To: T10 Technical Committee  
From: Amr Wassal, PMC-Sierra (amr\_wassal@pmc-sierra.com)  
Date: 7 July 2006  
Subject: 06-324r0 SAS-2 modifications to the SAS Speed Negotiation

### **Suggested changes to chapter 6 (Phy Layer)**

**Figure 122 — SAS SNW-1 and SNW-2 speed negotiation windows**

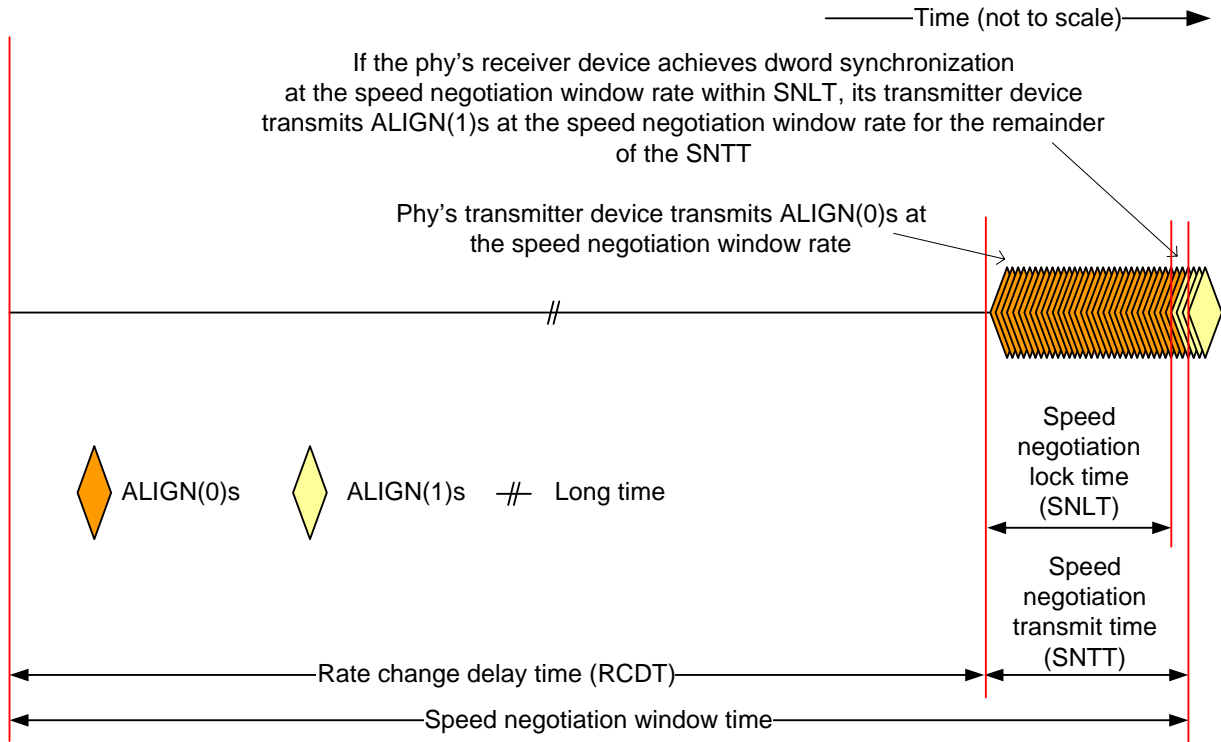
Figure 122 defines the SAS speed negotiation window for SNW-1 and SNW-2, including:

- a) speed negotiation window time;
- b) speed negotiation window rate;
- c) rate change delay time (RCDT);
- d) speed negotiation transmit time (SNTT); and

e) speed negotiation lock time (SNLT)

**Figure 123 — SAS SNW-3 speed negotiation window**

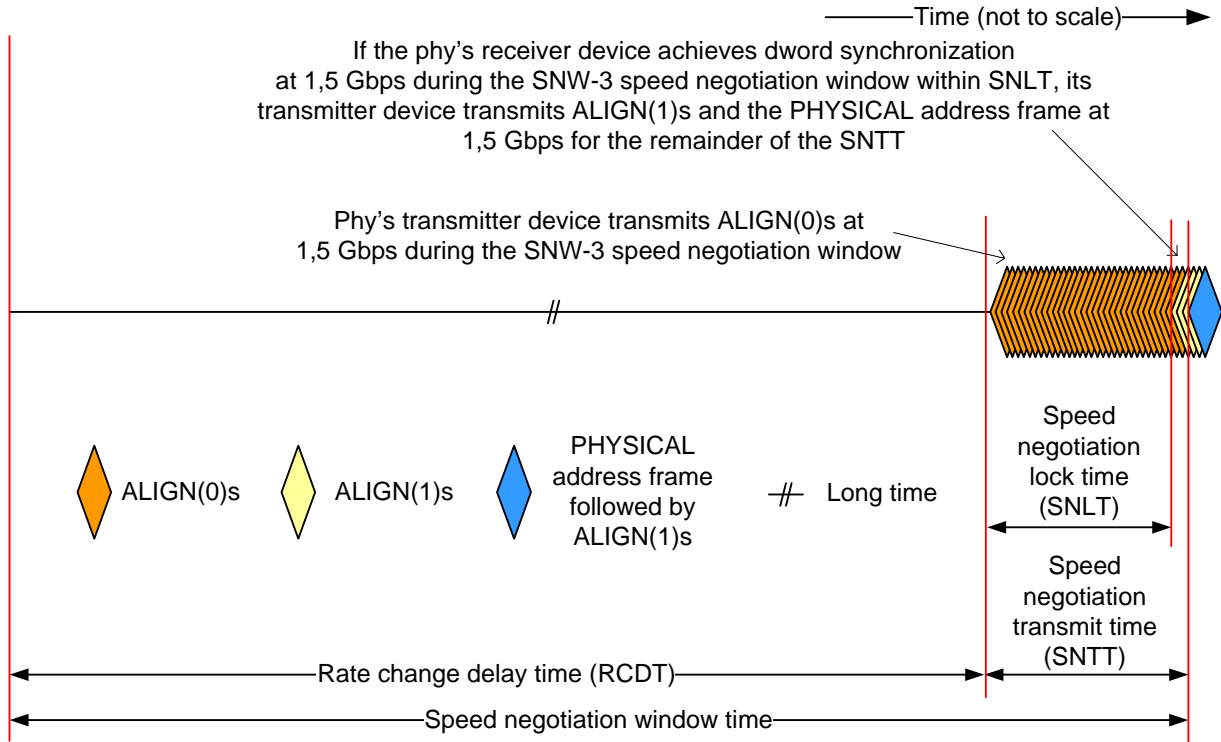
Figure 123 defines the SAS SNW-3 speed negotiation window, including:

- a) speed negotiation window time;
- b) speed negotiation window rate of 1,5 Gbps;
- c) rate change delay time (RCDT);
- d) speed negotiation transmit time (SNTT); and

e) speed negotiation lock time (SNLT).

**Figure 124 — SAS SNW-Final speed negotiation window**

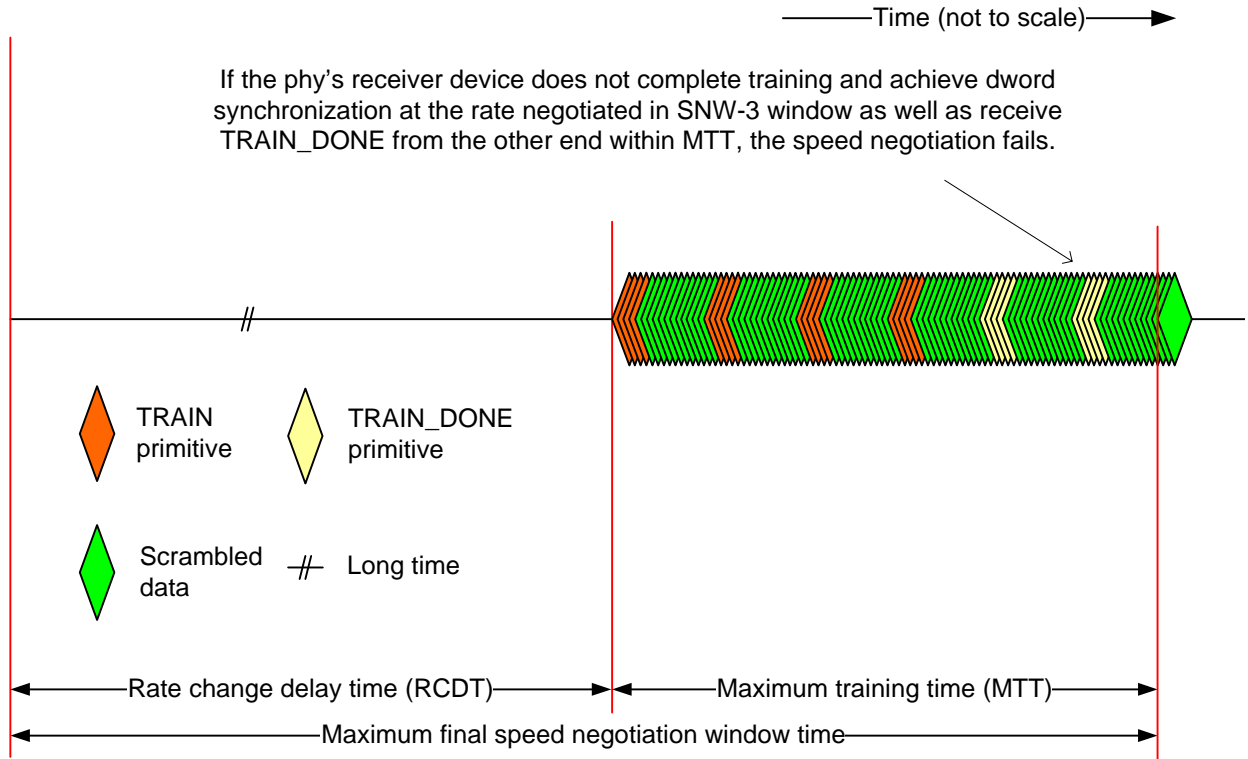
Figure 124 defines the SNW-Final speed negotiation window, including:

- a) Maximum final speed negotiation window time;
- b) rate change delay time (RCDT); and

c) maximum training time (MTT).

**Figure 125 — SAS speed negotiation sequence (phy A: G1, G2, G3, phy B: G2 only)**

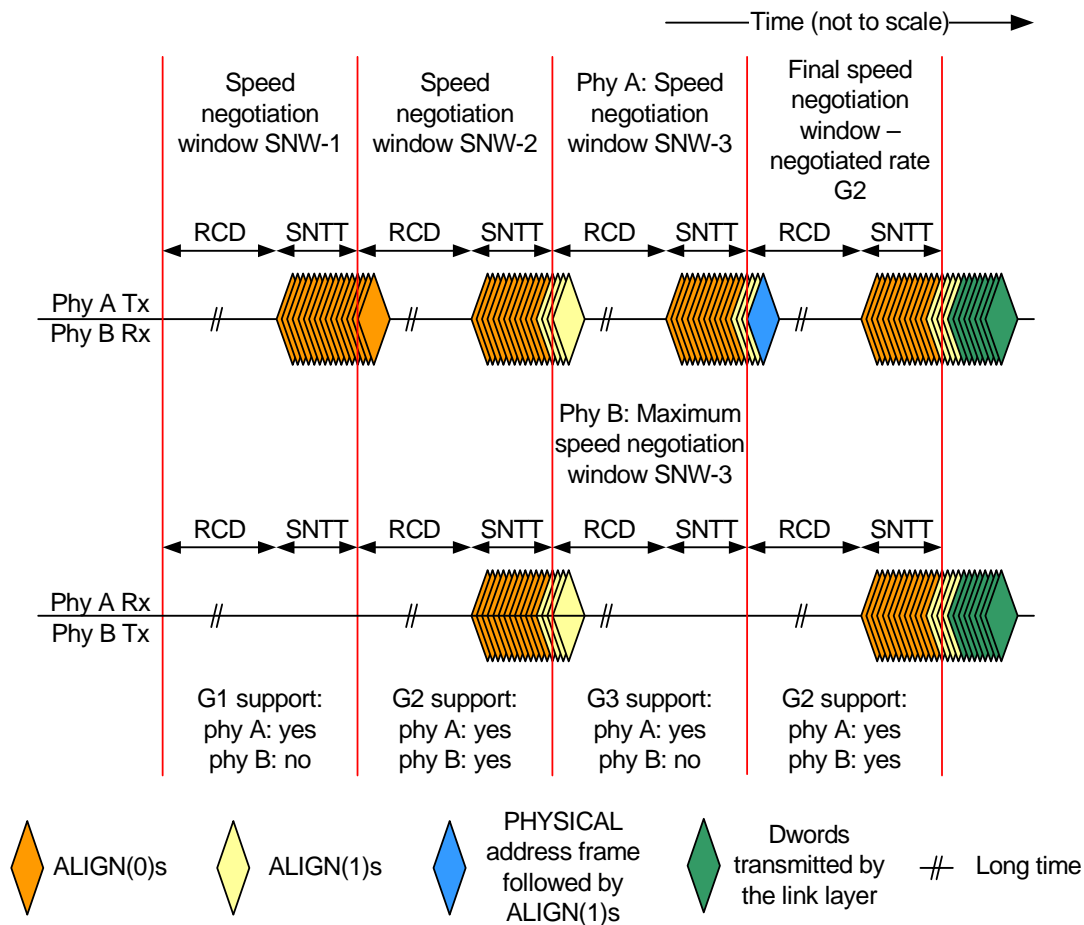
Figure 125 shows speed negotiation between a phy A that supports G1 through G3 and a phy B that only supports G2. Both phys run:

- 1) the SNW-1 speed negotiation window, supported by phy A but not by phy B;
- 2) the SNW-2 speed negotiation window, supported by both phys; and
- 3) the SNW-3 speed negotiation window, supported by phy A but not by phy B.

Phy A reaches its limit because it has run a speed negotiation window that does not detect a valid physical link rate (i.e., SNW-3) after having detected a valid physical link rate in a previous speed negotiation window (i.e., G2 in SNW-2). Phy B reaches its limit because it has reached the speed negotiation window corresponding to its highest support physical link rate plus one (i.e., SNW-3). Both phys select G2 for the SNW-Final speed negotiation window to establish the negotiated physical link rate.

Figure 126 — SAS speed negotiation sequence - phy reset problem

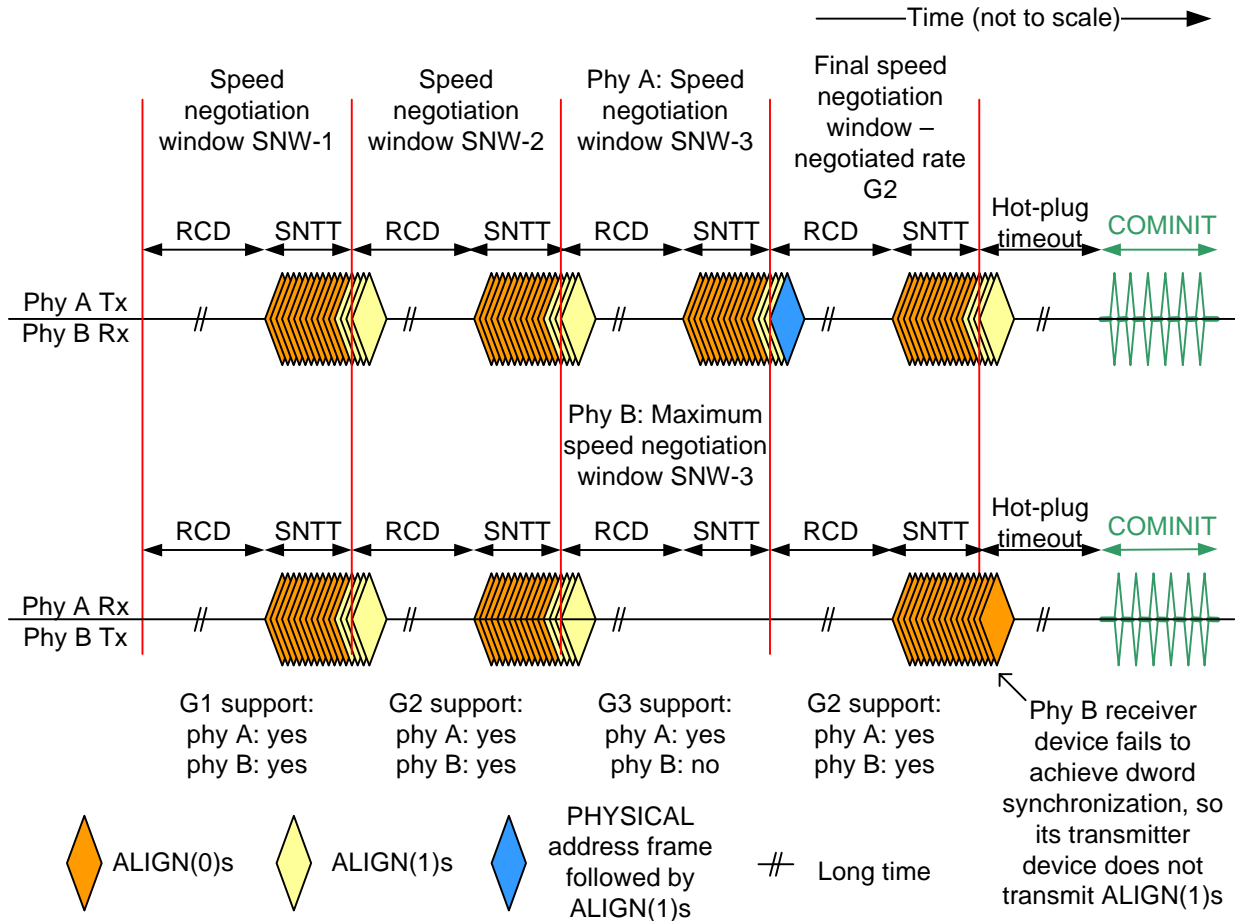
Figure 126 shows a speed negotiation sequence where phy B does not achieve dword synchronization during the final speed negotiation window. If this occurs, the handshake is not complete and the phy reset sequence is retried.

**Figure 127 — SAS speed negotiation sequence (phy A: G1, G2, G3 or higher, phy B: G1, G2, G3 or higher)**

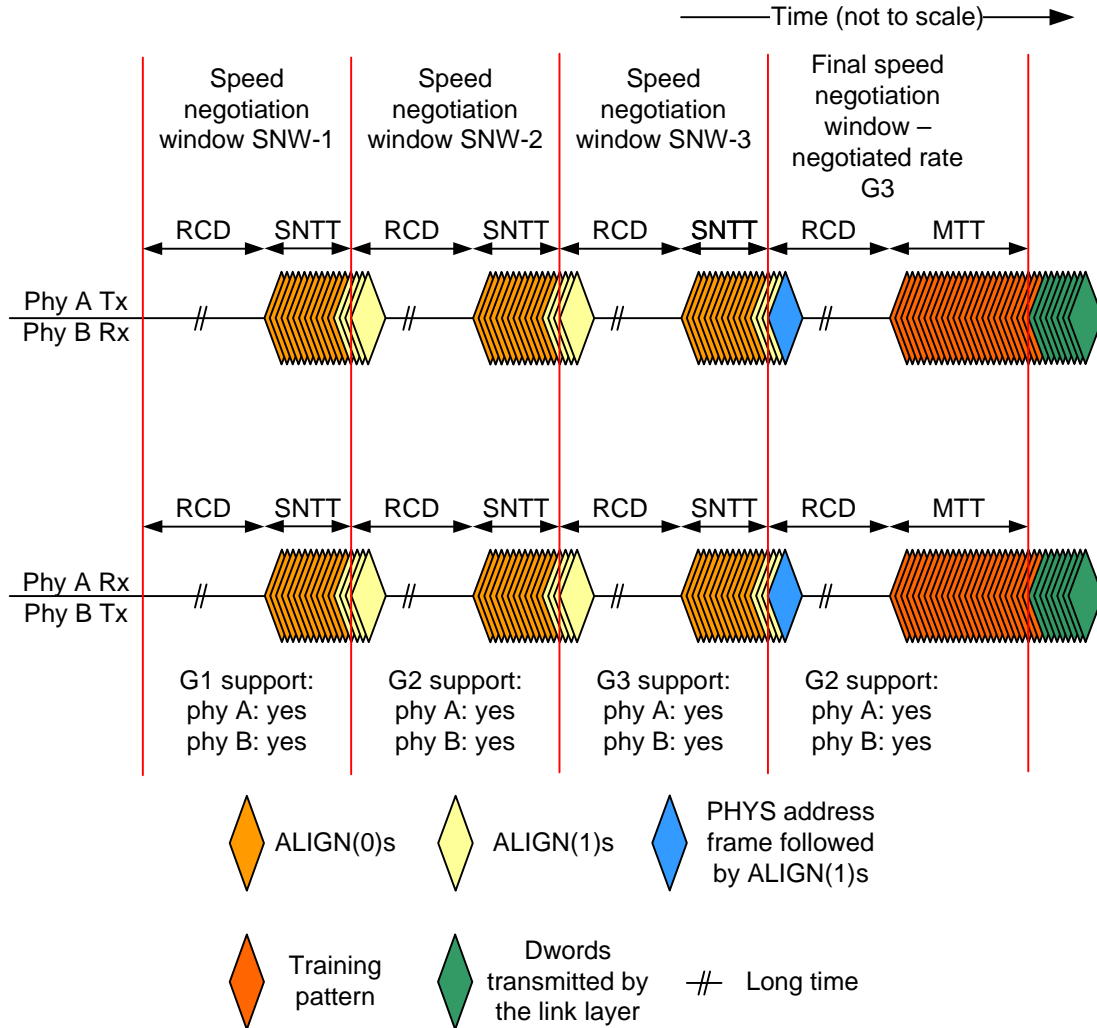
Figure 127 show speed negotiation between a phy A and a phy B that both support G3 rate or higher. Both phys run:

- 1) the SNW-1 speed negotiation window, supported by both phys;
- 2) the SNW-2 speed negotiation window, supported by both phys; and
- 3) the SNW-3 speed negotiation window, supported by both phys where the PHYSICAL address frame is exchanged and the highest common rate supported by both phys is negotiated; and

4) the SNW-Final speed negotiation window, supported by both phys where training is done.

Figure 128 — SAS speed negotiation sequence - SNW-3 (maximum SNW) phy reset problem

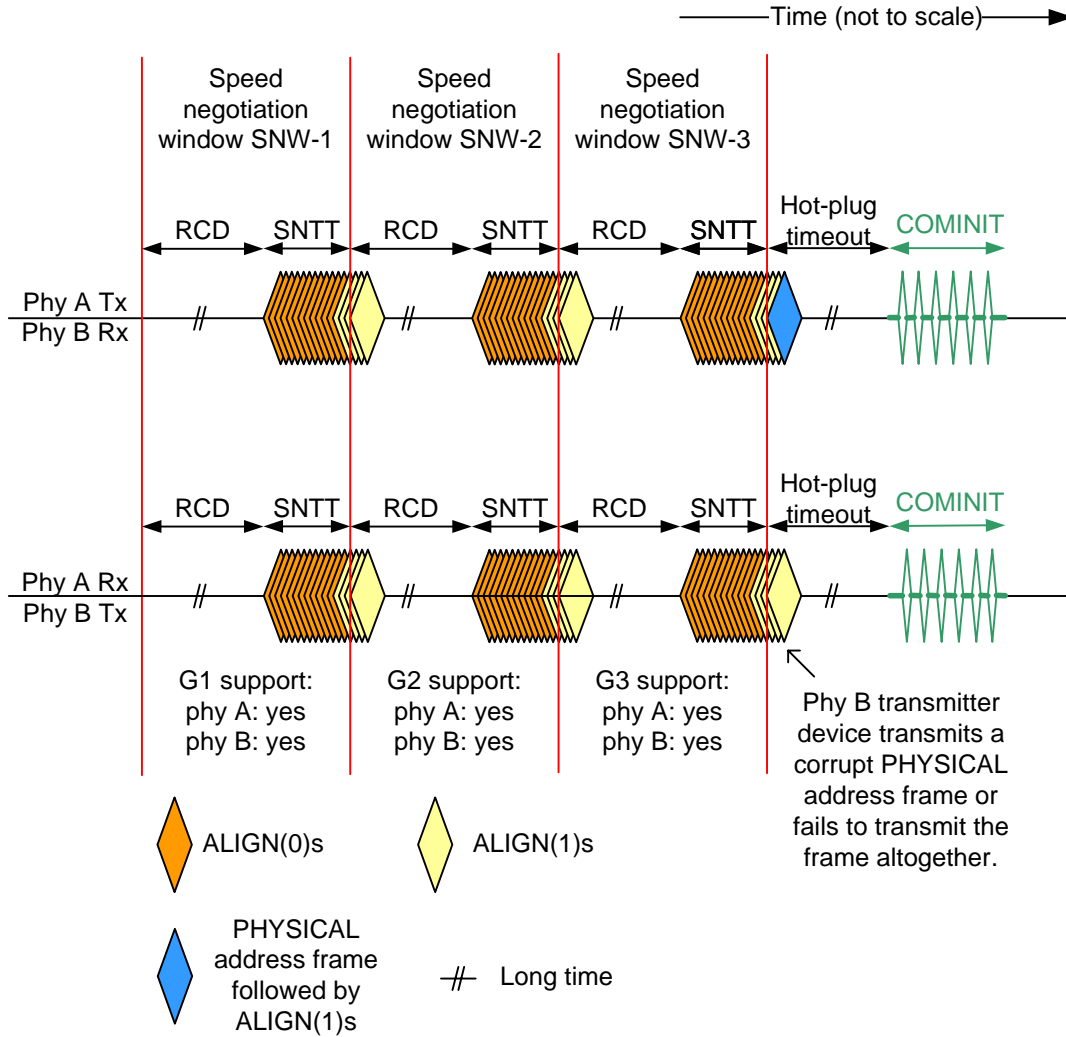
- 1) the phys do not exchange PHYSICAL address frames properly in SNW-3 window (see Figure 128); or

Figure 129 — SAS speed negotiation sequence - training (SNW-Final) phy reset problem

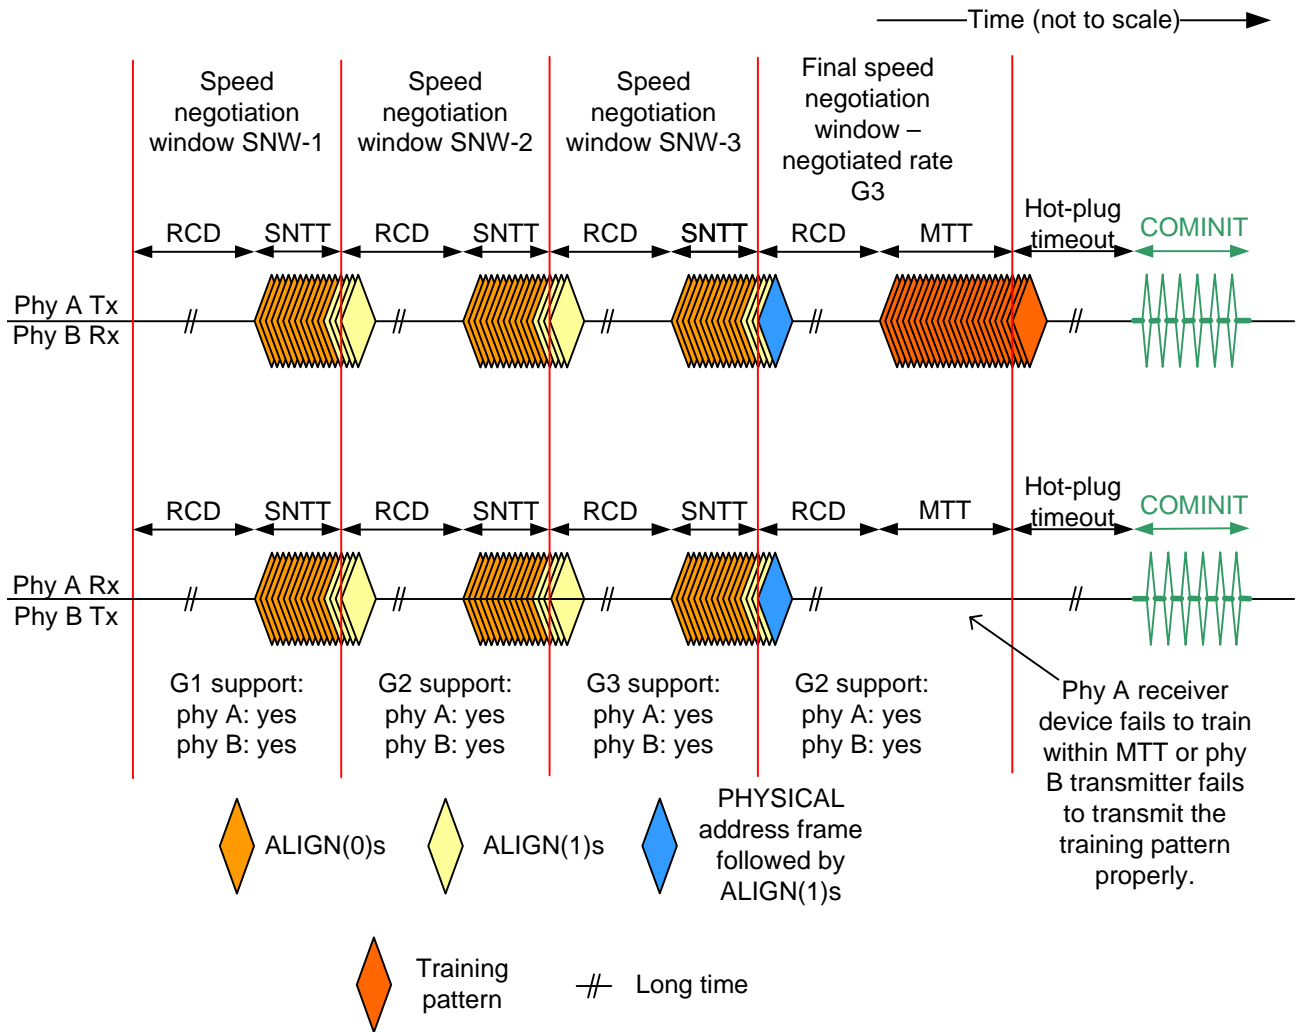
2) either phy does not complete training within the MTT interval (see Figure 129)..

Figure 131 — SP (phy layer) state machine - SAS speed negotiation states

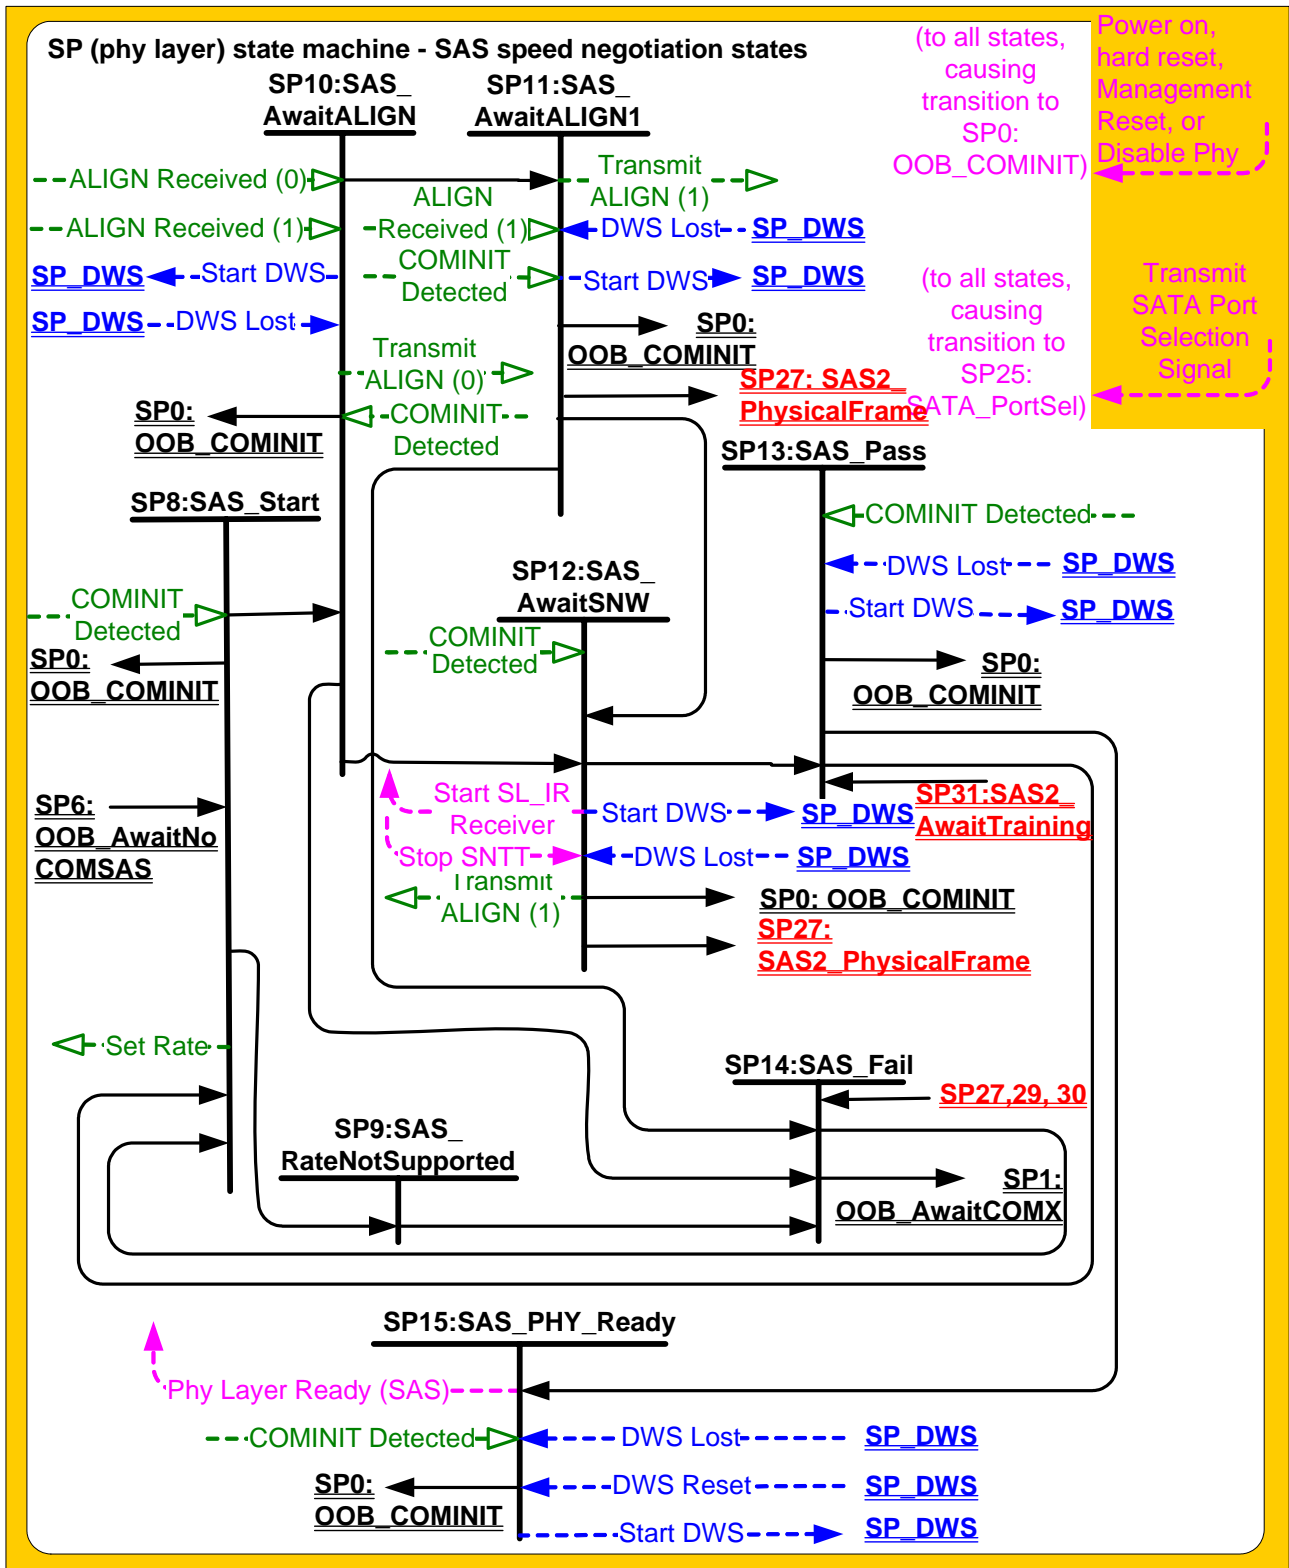
Figure 131 shows the SAS speed negotiation states, in which the phy has detected that it is attached to a SAS phy or expander phy rather than a SATA phy, and performs the SAS speed negotiation sequence. These states are indicated by state names with a prefix of SAS.
